# **SUPPLEMENT**

*In Response to CEC Data Adequacy Review*

## **Application for Certification (07-AFC-3)**

## **CPV Sentinel Energy Project Riverside County, California**

Winter 1988-91 Wintec Windrose

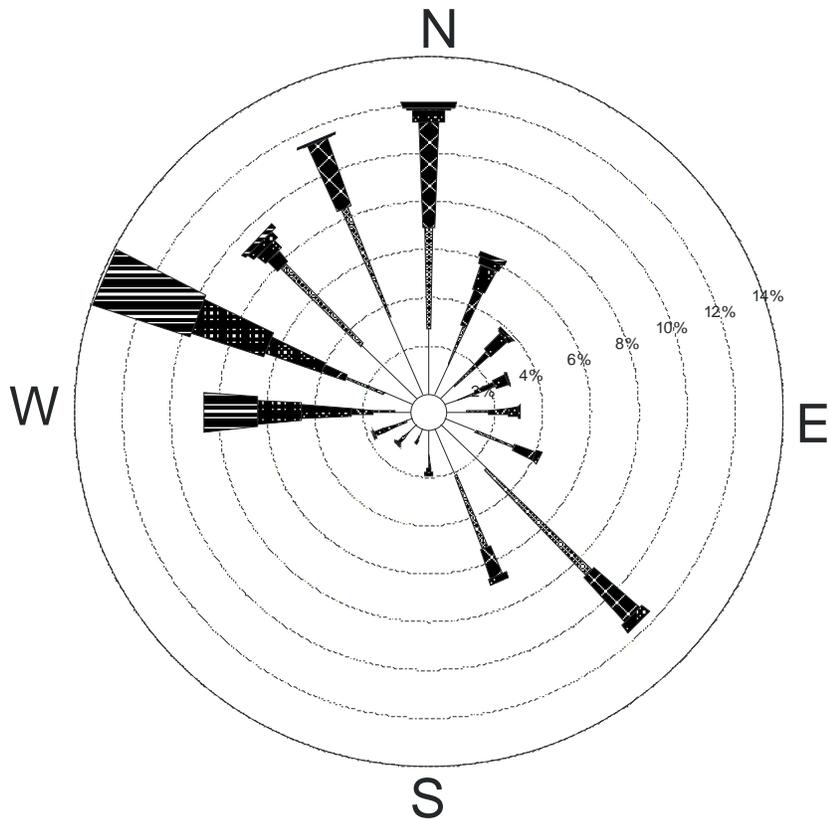
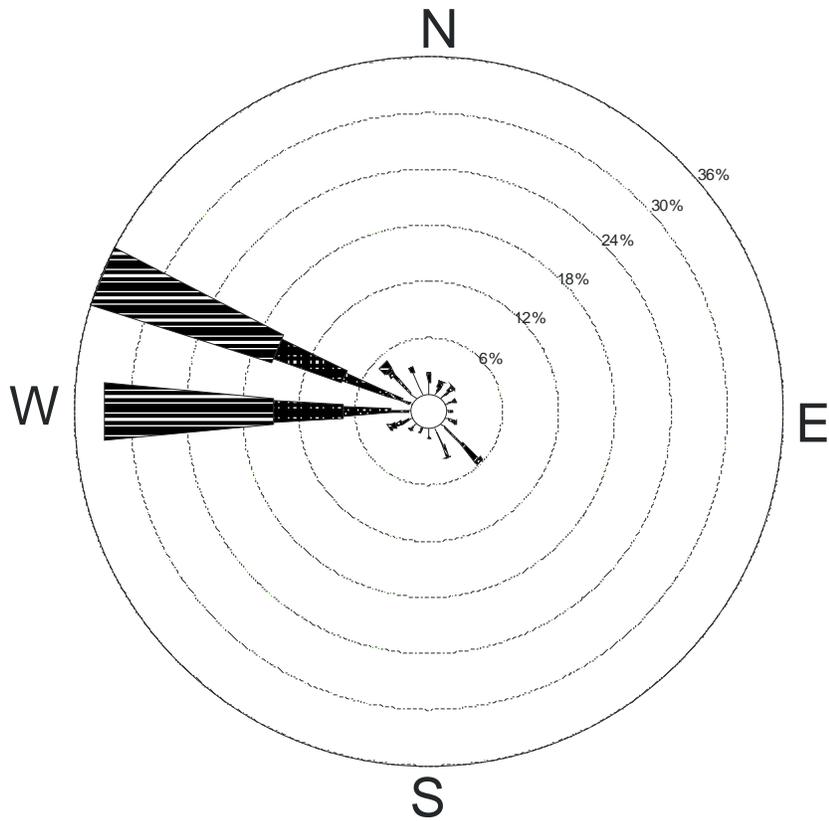
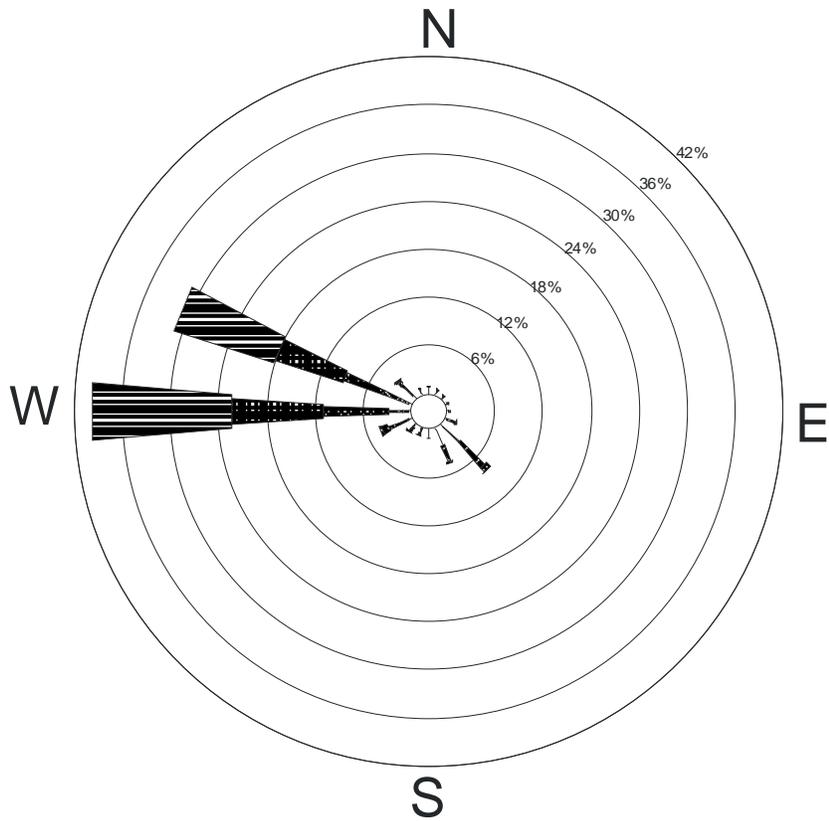
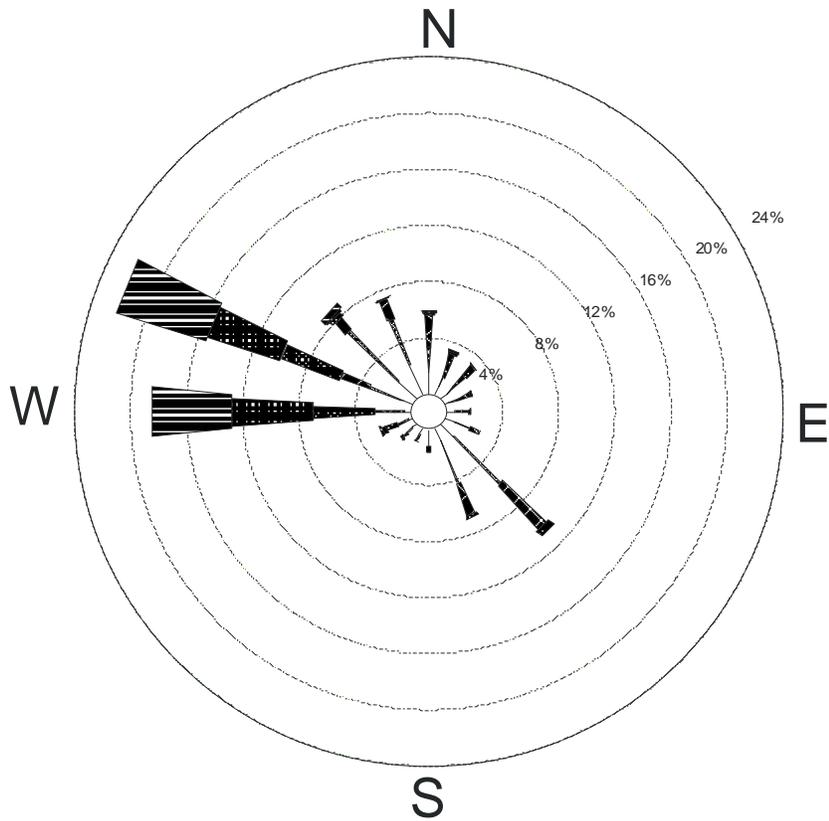
2	Appendix B (g) (8) (H) (ii)	The data shall include quarterly wind tables and wind roses, ambient temperatures, relative humidity, stability and mixing heights, upper atmospheric air data, and an analysis of whether this data is representative of conditions at the project site.	Please provide the quarterly wind tables and wind roses for the meteorological data used in the AFC.	<b>Quarterly wind tables and wind roses are provided in Appendix A.</b>
3	Appendix B (g) (8) (J) (ii)	Potential offset sources, including locations, and quantity of emission reductions;	Provide a list of ERC holders (including the locations of these potential ERCs) that have been contacted to enter negotiations for the VOC, PM10 and SO2 ERCs and/or for the NOx RTCs. You may submit this information with a request for confidential status.	<b>Given the limited availability of PM10 and SOX ERCs on the market, it is anticipated that the project will obtain necessary offsets for these two pollutants from the SCAQMD Priority Reserve. Nevertheless, Applicant has made market inquiries in order to satisfy the due diligence requirement for obtaining offsets from the Priority Reserve. It is anticipated that VOC ERCs will be acquired on the open market, and Applicant has also made market inquiries regarding this pollutant. Given the relatively plentiful supply of NOx RTCs on the</b>

**WATER BALANCE DIAGRAM**  
 CPV Sentinel Energy Project  
 July 2007  
 28067168  
**URS**  
 CPV Sentinel, LLC  
 Riverside County, California  
**FIGURE 2.4-6 (REVISED)**

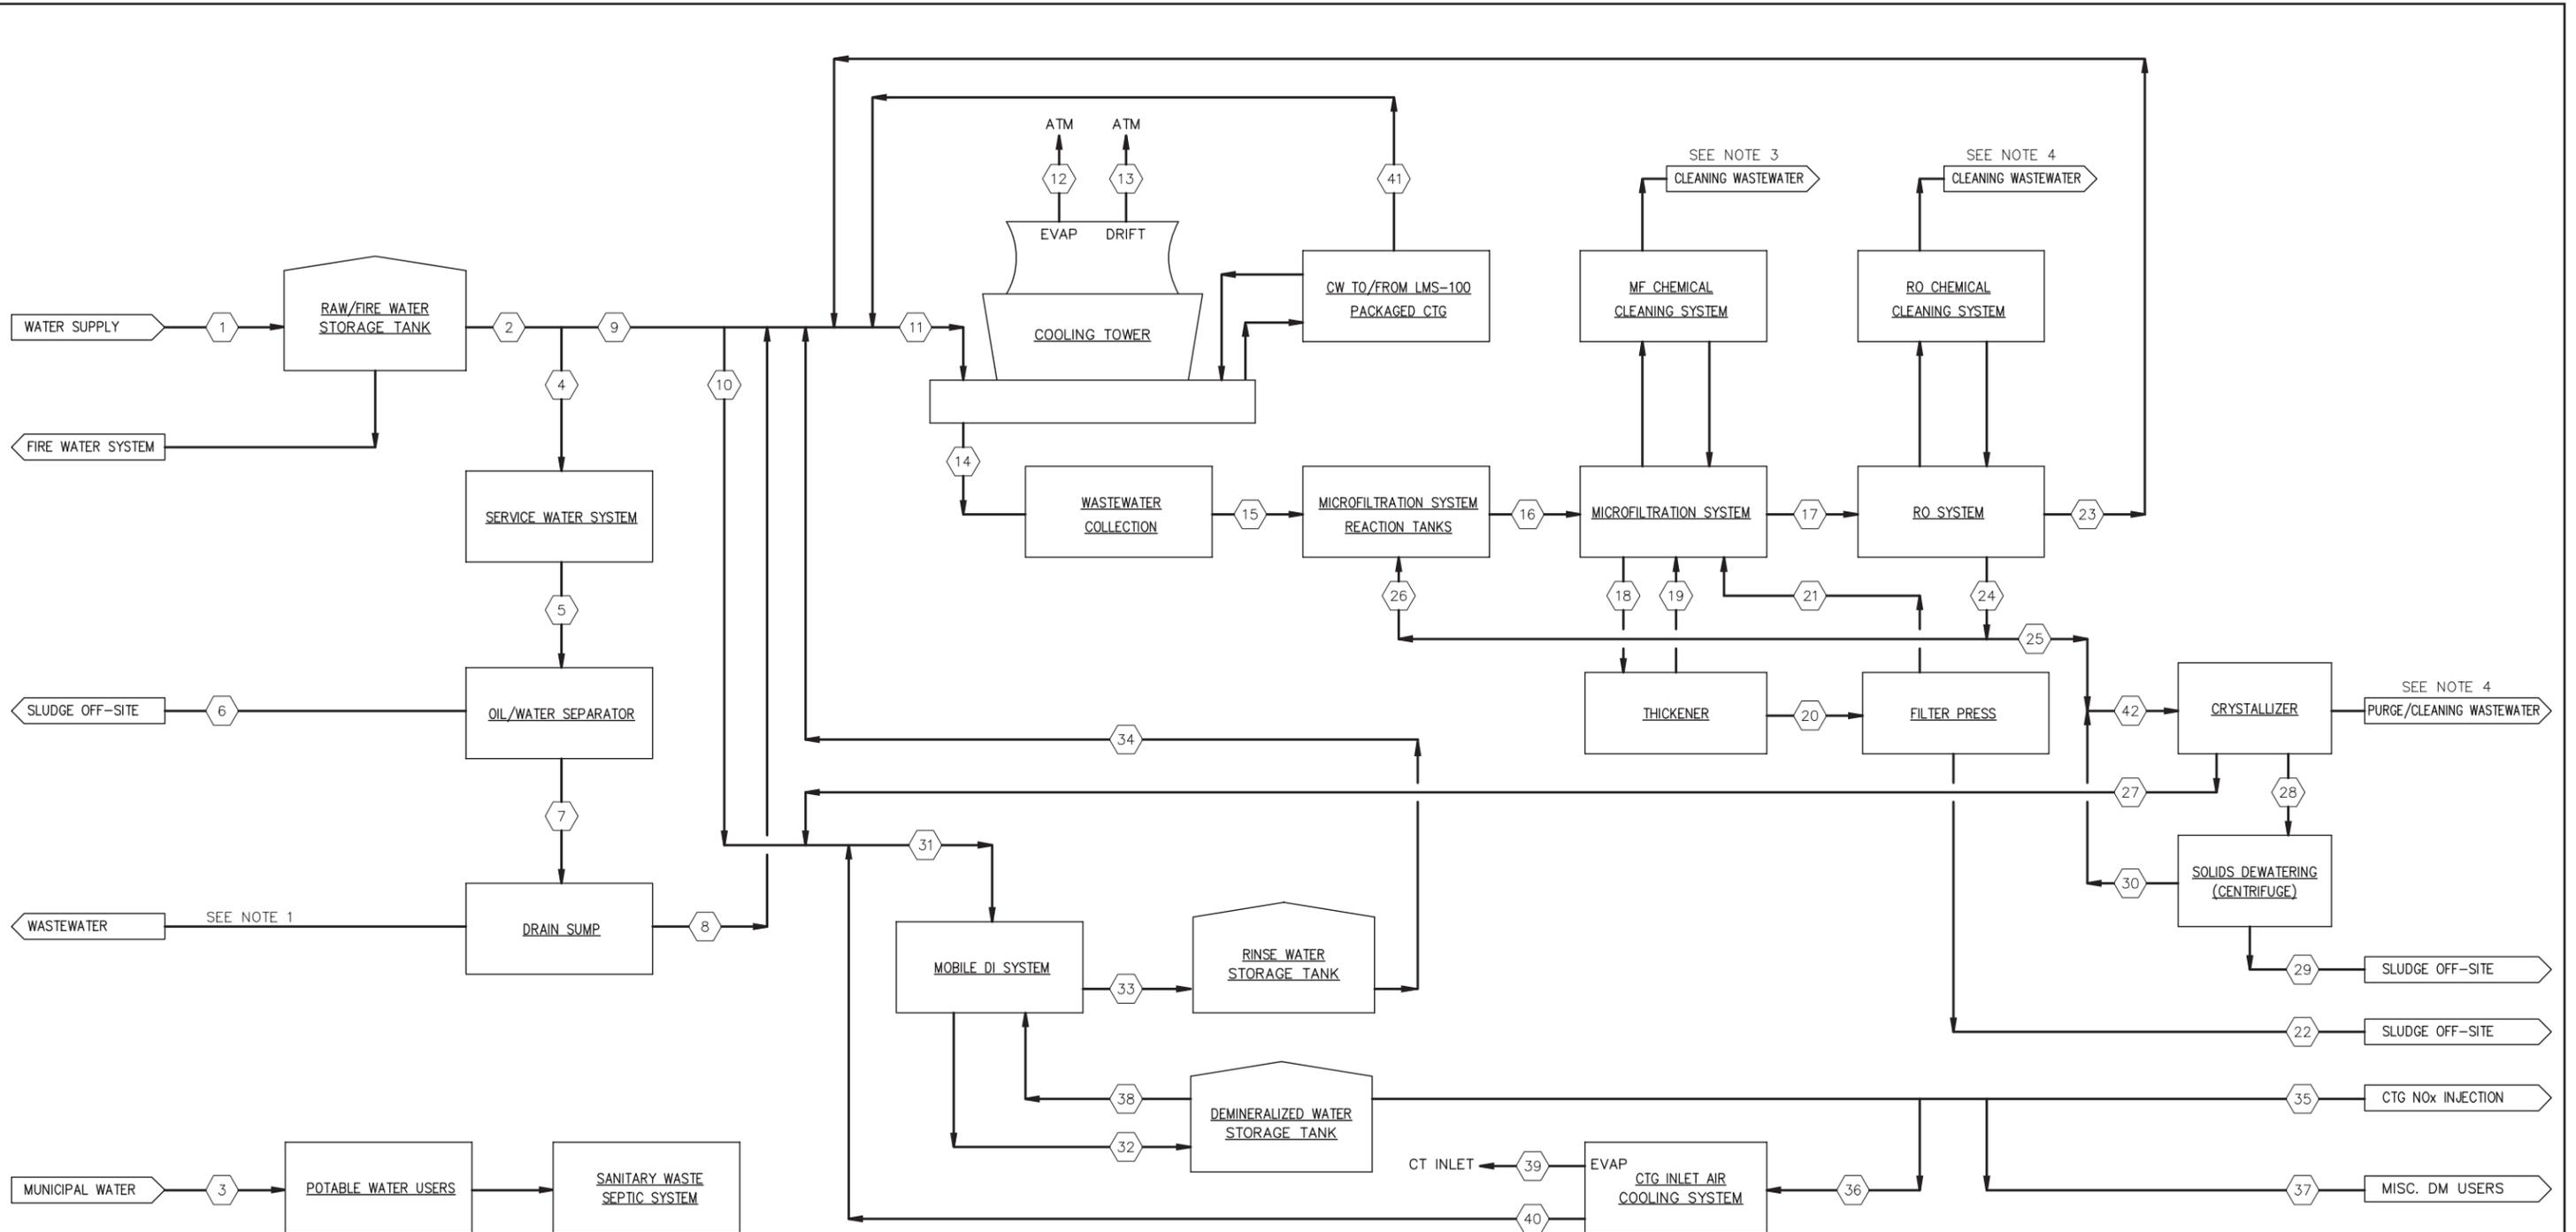
17	Appendix B (g) (14) (C) (vii)	<p>Provide water mass balance and heat balance diagrams for both average and maximum flows that include all process and/or ancillary water supplies and wastewater streams. Highlight any water conservation measures on the diagram and the amount that they</p>	<p>Water mass balance and heat balance diagrams are provided, but they do not show the average and maximum flows. Water mass balance and heat balance diagrams that show the average and maximum flows are required.</p>	<p>Revised tables and figures responding to this request are provided in Appendix H.</p> <p>For the Heat and Mass Balance Diagram, Figure 2.4-4, average and maximum flows for each stream are provided on Revised Table 2.4-3. For</p>

ID	SITING REGULATIONS	INFORMATION	INFORMATION REQUIRED TO MAKE AFC CONFORM WITH REGULATIONS	RESPONSE
		reduce water demand; and		<p><b>the Water Balance Diagram, Figure 2.4-6, average and maximum flows for each stream are provided on Revised Table 2.4-5.</b></p> <p><b>In addition, Figure 2.4-6 provided in the AFC should have referred to Table 2.4-5, not 2.4-4; therefore, a revised Figure 2.4-6 has been provided with the correct Table reference. Revised Tables 2.4-6 and 7.14-7 have also been provided in Appendix H to be consistent with Revised Table 2.4-5.</b></p>
